## ORIGINATION FORM

### Proposed Revisions to a Standard Plans Index

Index Number: 649-031

Index Title: MAST ARM ASSEMBLIES

**ELEVATION AND NOTES**

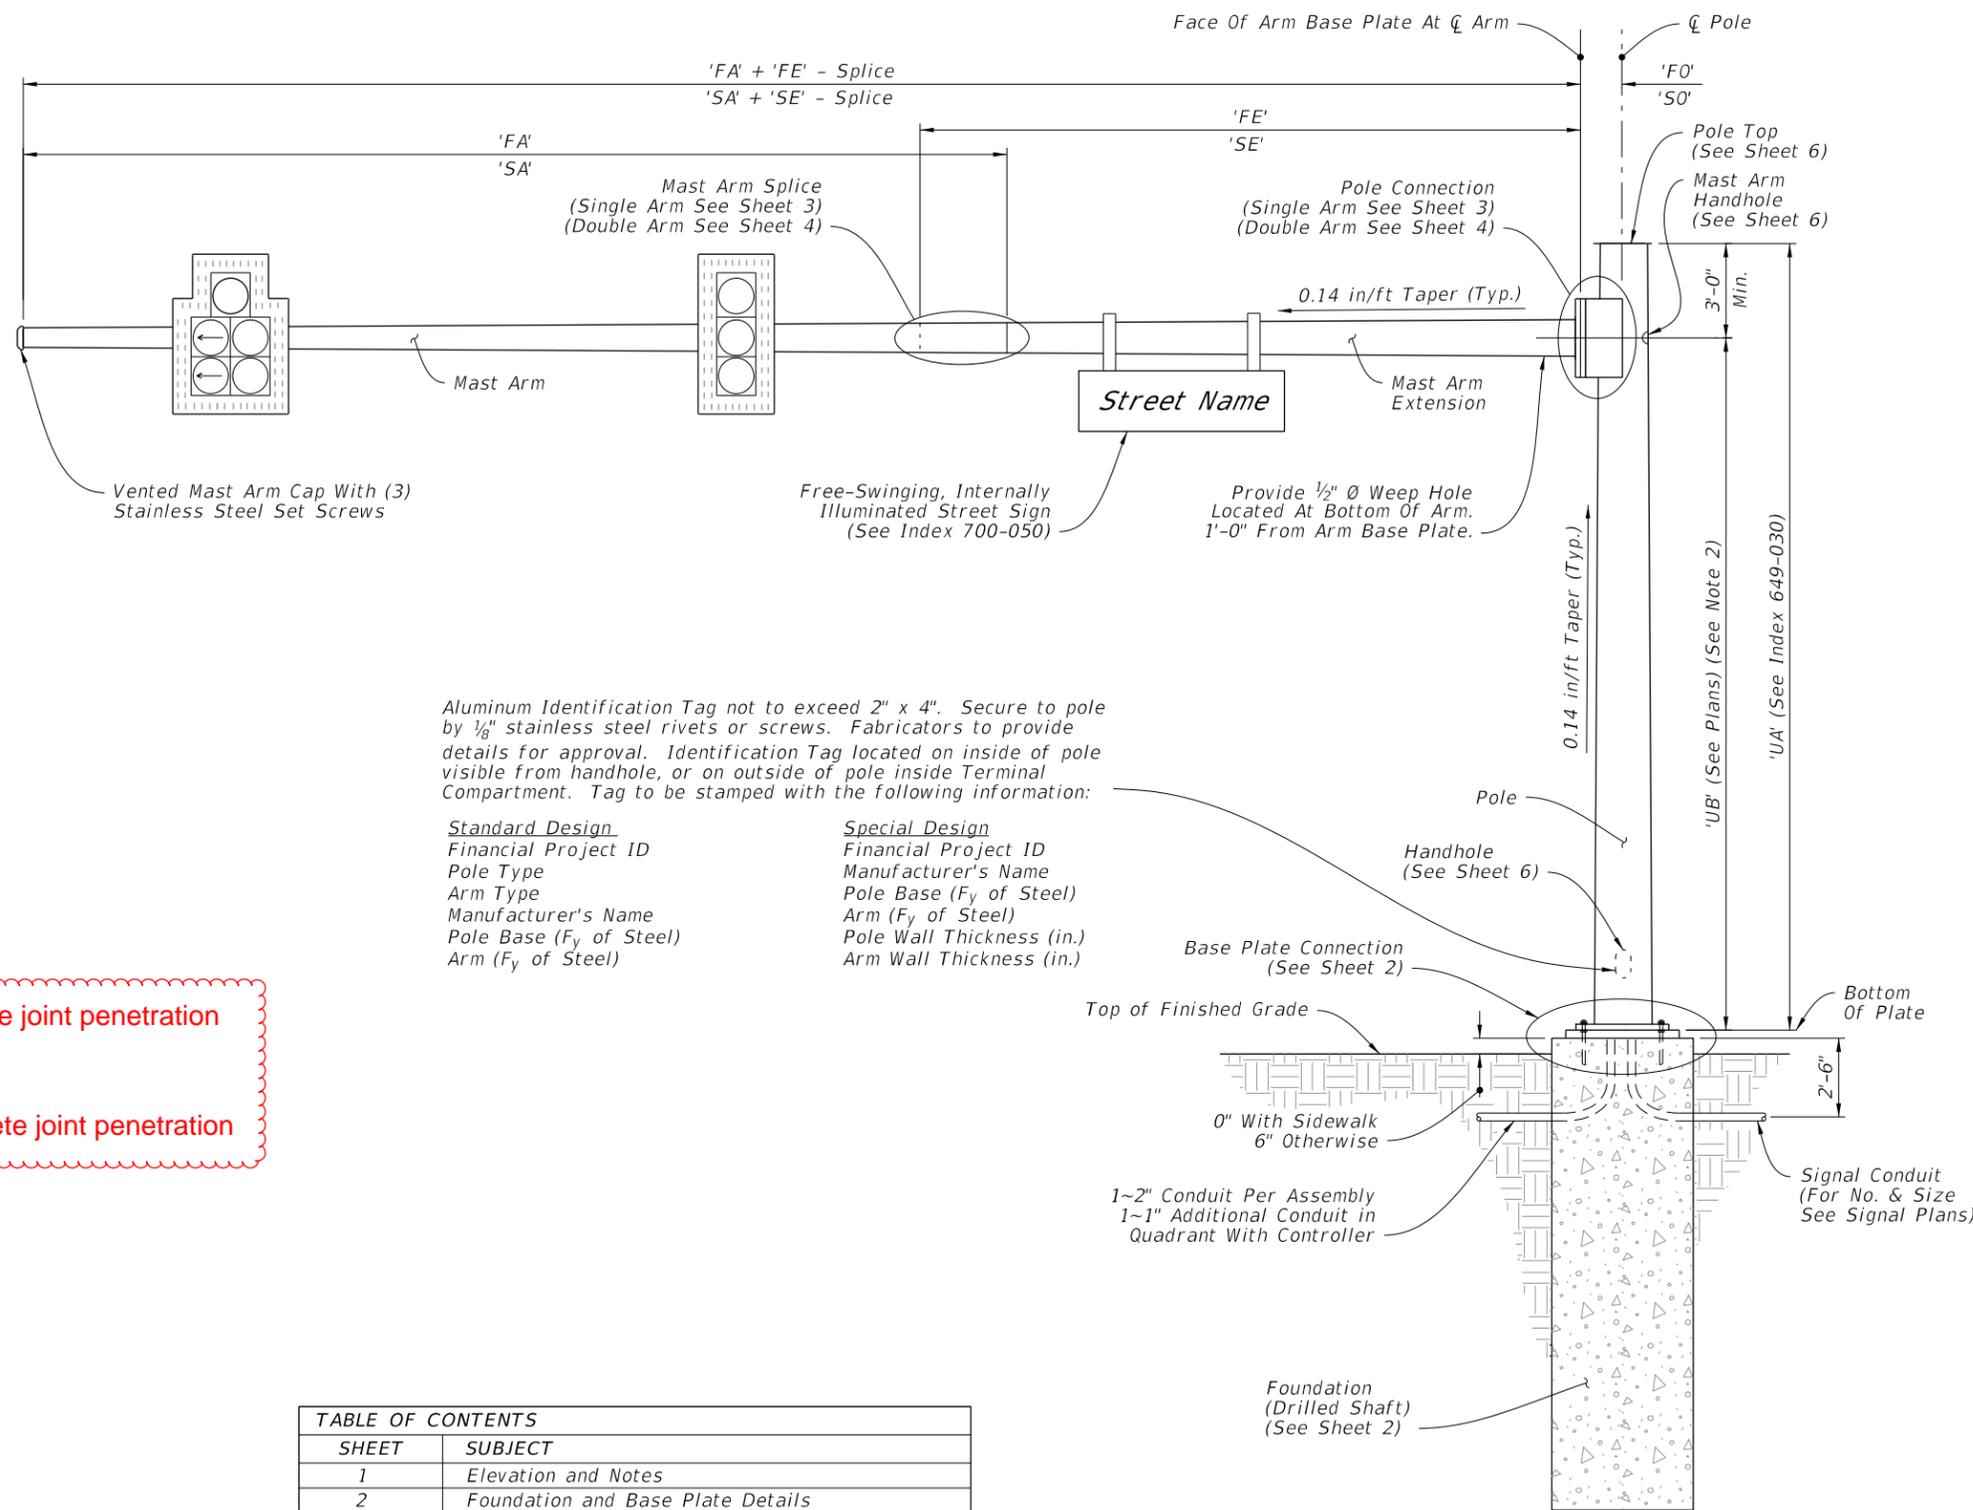
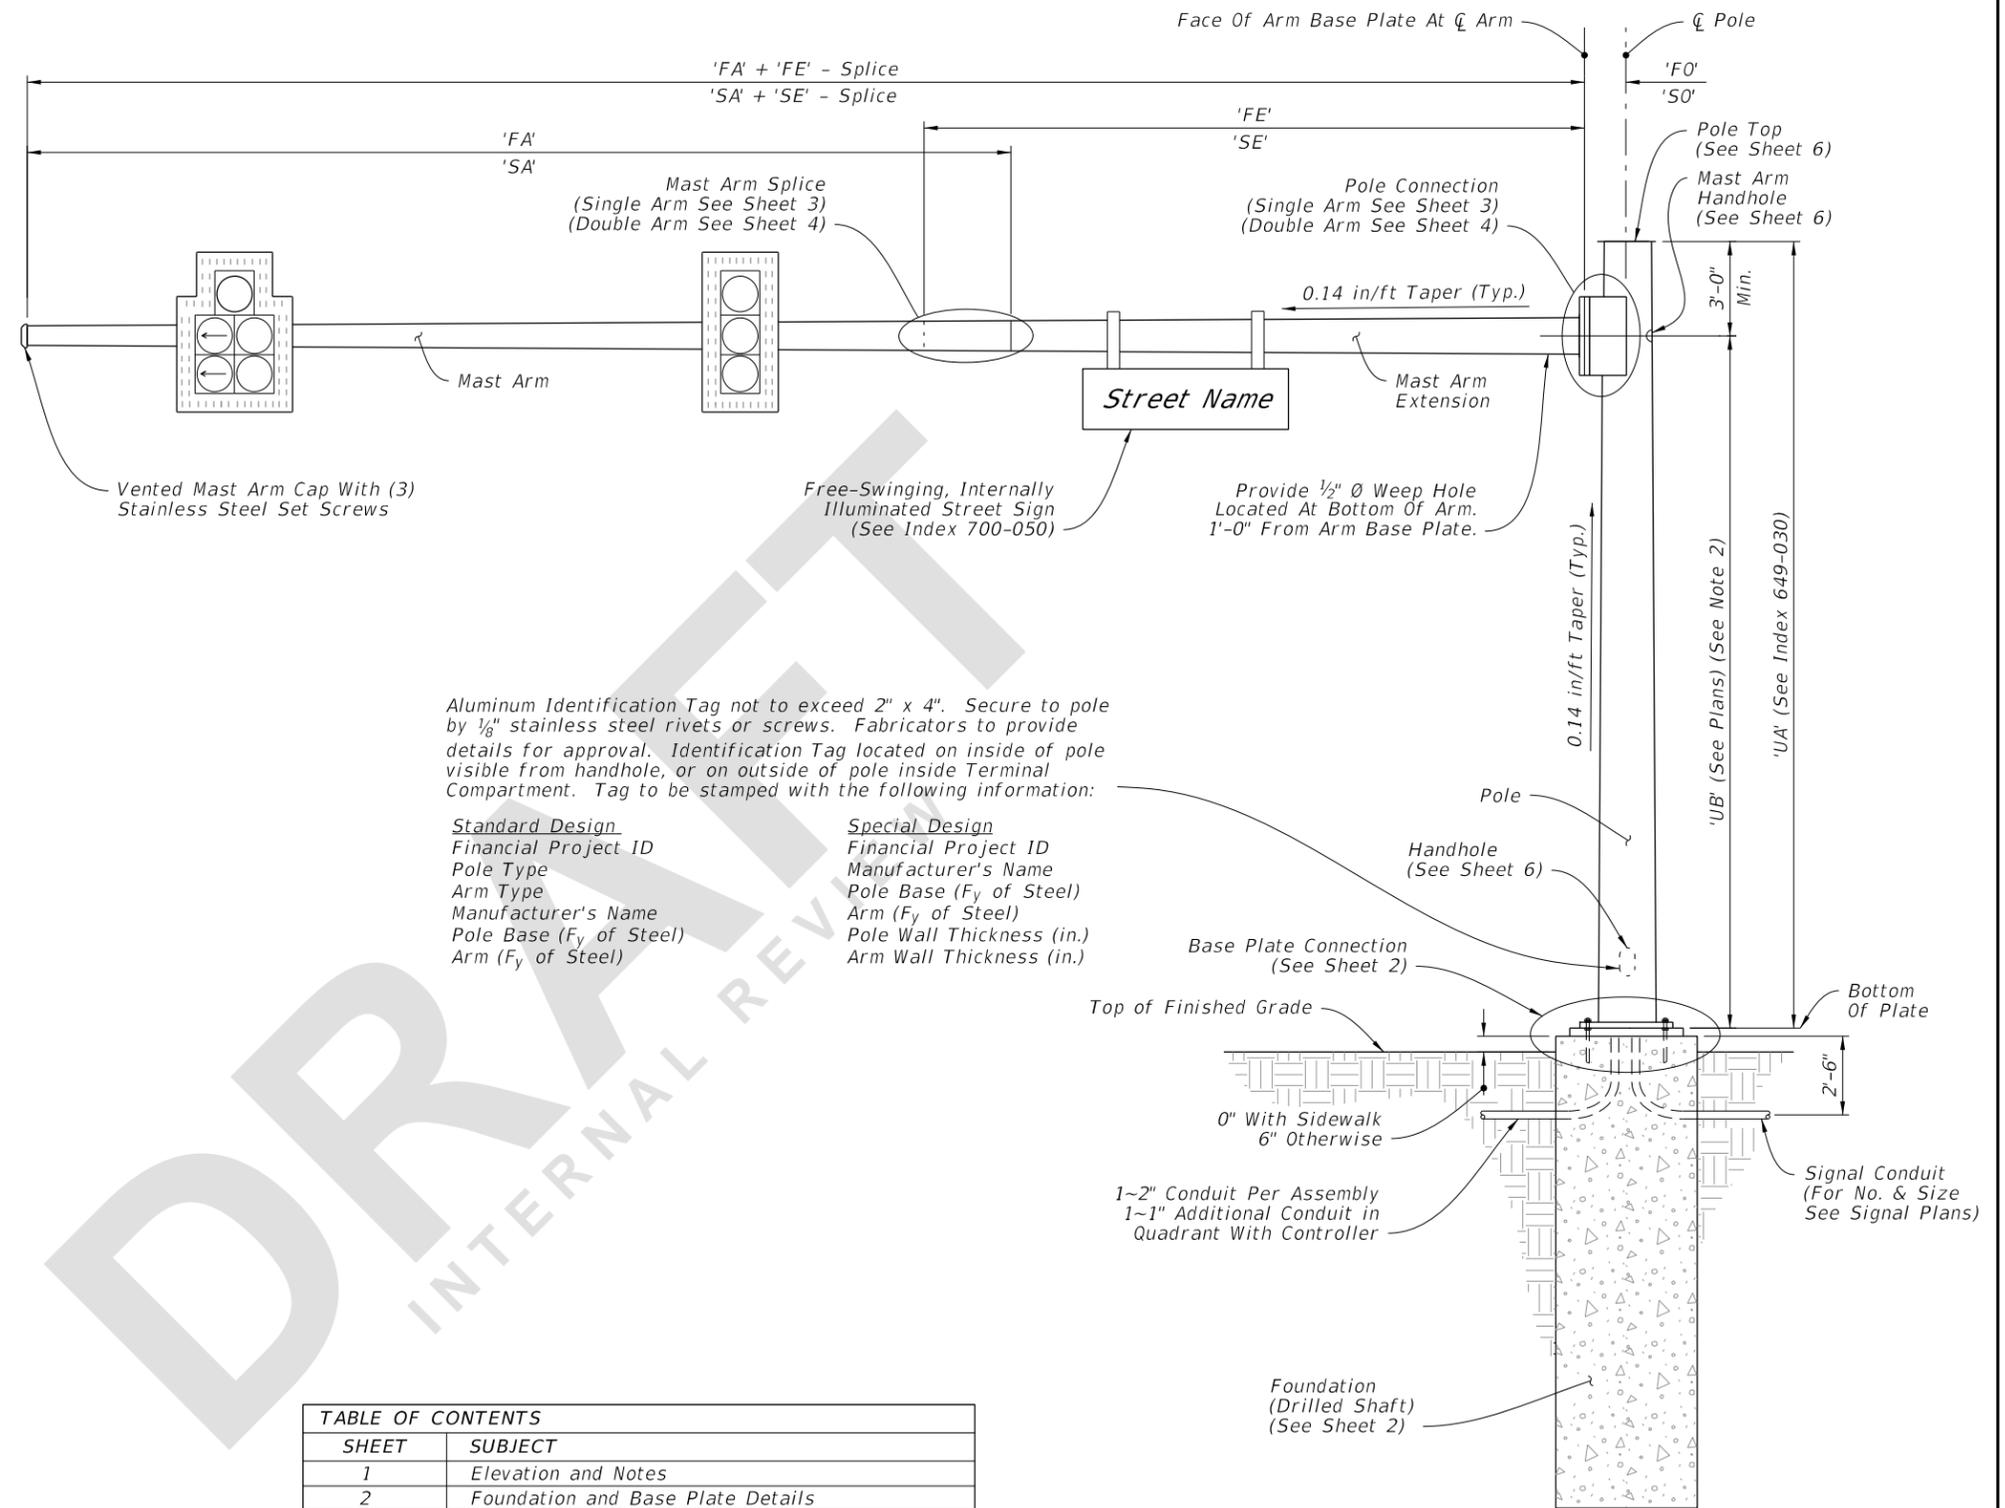
Sheet 1: Changed phrase from "full-penetration groove" to "complete joint penetration."

Sheet 1: Changing non-standard language to standard language consistent with AWS.

- Use a ~~full penetration groove weld~~ **complete joint penetration** weld within 6 inches of the circumferential tube-to-plate connection.
      - Use ~~full penetration groove welds on the female end section of telescopic (i.e., slip type) field splices for a minimum length of one and one-half times the inside diameter of the female section plus 6 inches.~~ **complete joint penetration**

- Use a complete joint penetration weld within 6 inches of the circumferential tube-to-plate connection.
      - Use complete joint penetration welds on the female end section of telescopic (i.e., slip type) field splices for a minimum length of one and one-half times the inside diameter of the female section plus 6 inches.

ARM SPLICE

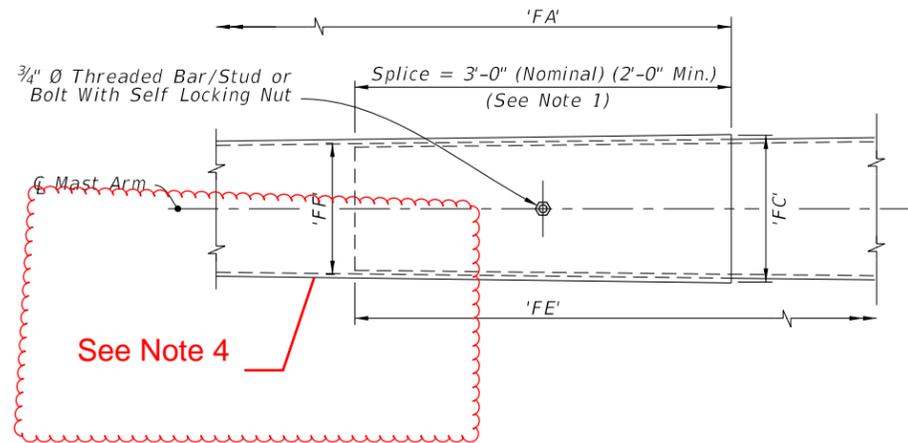
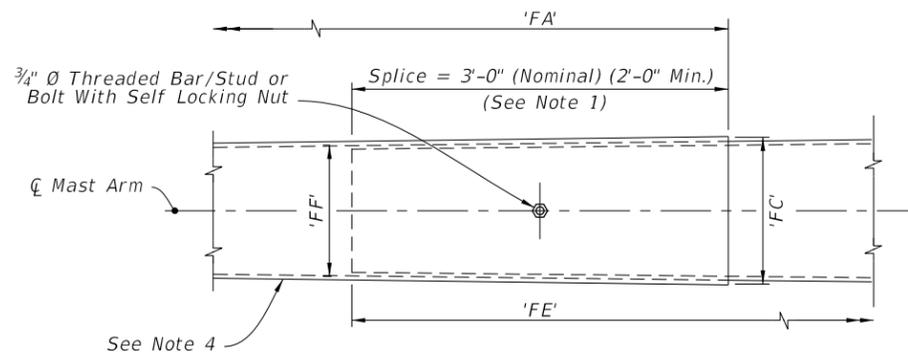
Sheet 3: Added a note about the diameter of the female splice.

Sheet 3: Fabricators were having a problem getting the required splice length due to the diameters of the splice sections. We added some tolerance so that they could more easily attain the required splice length.

**4. On the outer mast arm section, the manufacturer may increase both the tip diameter and the base diameter of the female section of the splice by up to 1/8" to meet the required 3'-0" minimum lap splice.**  
**SINGLE ARM CONNECTIONS & SPLICE DETAILS**

1. Install the 'Slip Joint' splice with a tight fit and no change in the Mast Arm taper due to the splice.
2. Details shown on this sheet are for 12 sided pole sections. However, sections with more than 12 sides and round sections are permitted provided outside diameter and wall thickness are not reduced.
3. Match mark the Arm and Connection Plates to ensure proper assembly and the seam weld is in the proper location (seam located at the bottom side of the Arm).
4. On the outer mast arm section, the manufacturer may increase both the tip diameter and the base diameter of the female section of the splice by up to 1/8" to meet the required 3'-0" minimum lap splice.

ARM SPLICE

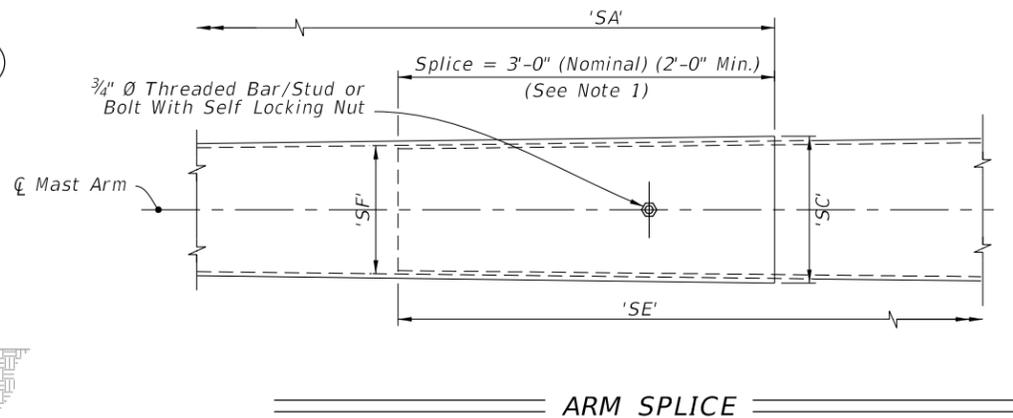
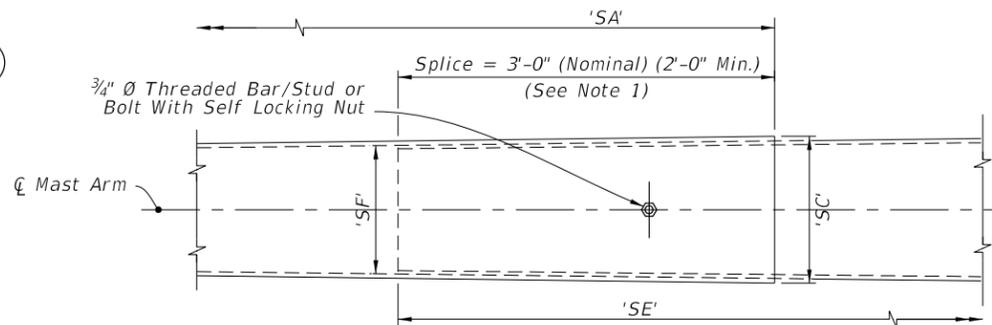
Sheet 4: Changed weld detail to say "CJP."

Sheet 4: Changing non-standard language to standard language consistent with AWS.

**HANDHOLE AND POLE TOP DETAILS**

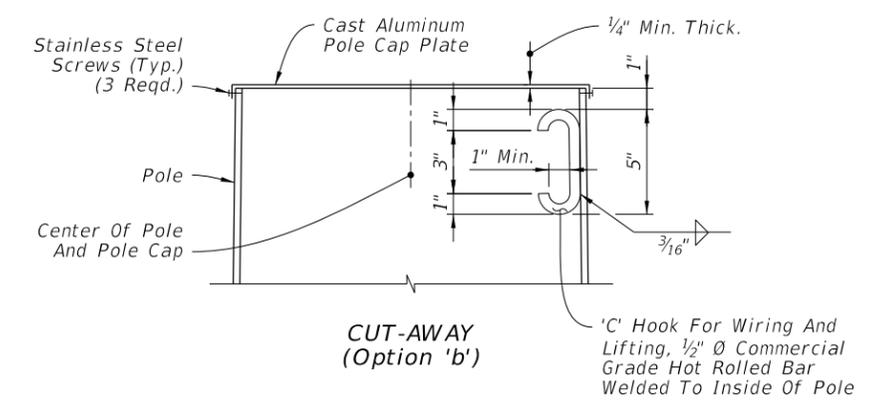
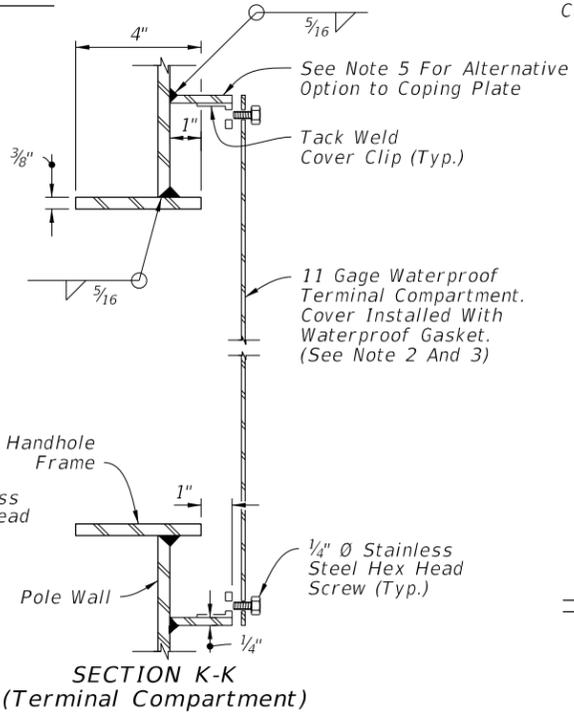
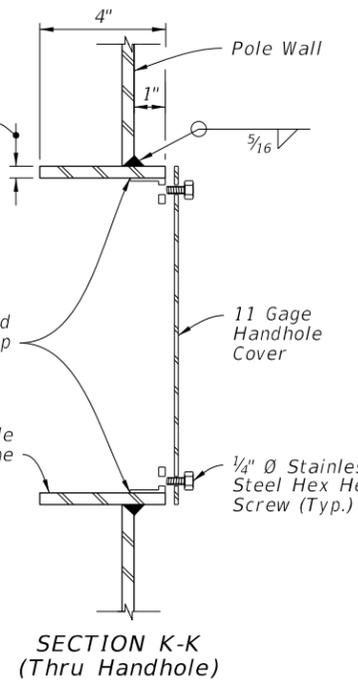
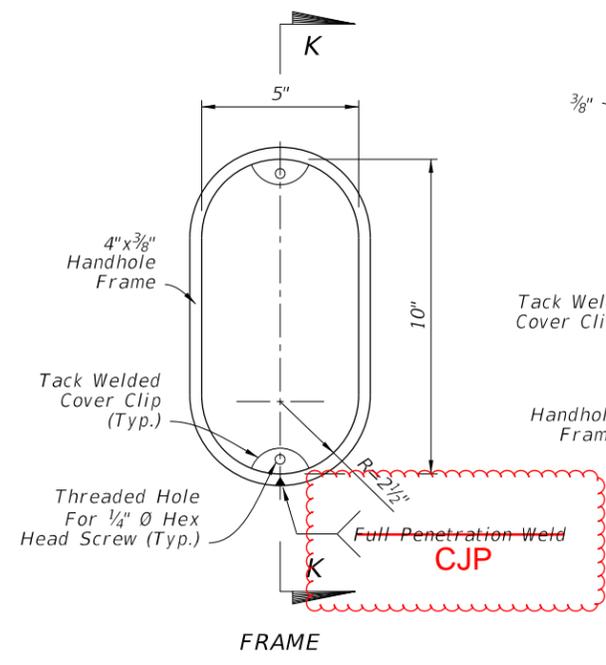
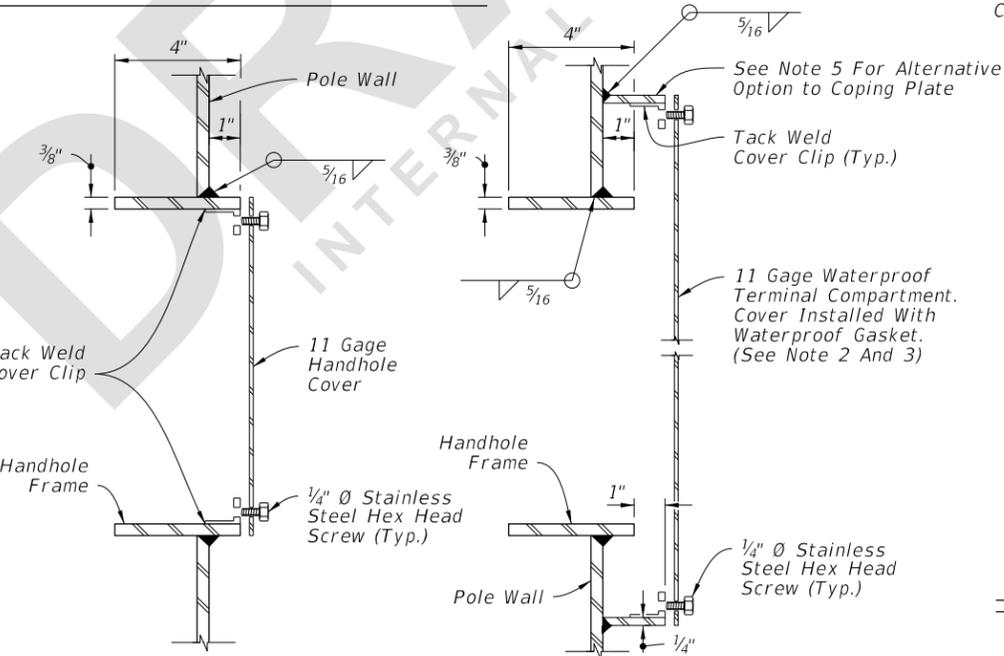
Sheet 6: Changed weld detail to say "CJP."

Sheet 6: Changing non-standard language to standard language consistent with AWS.
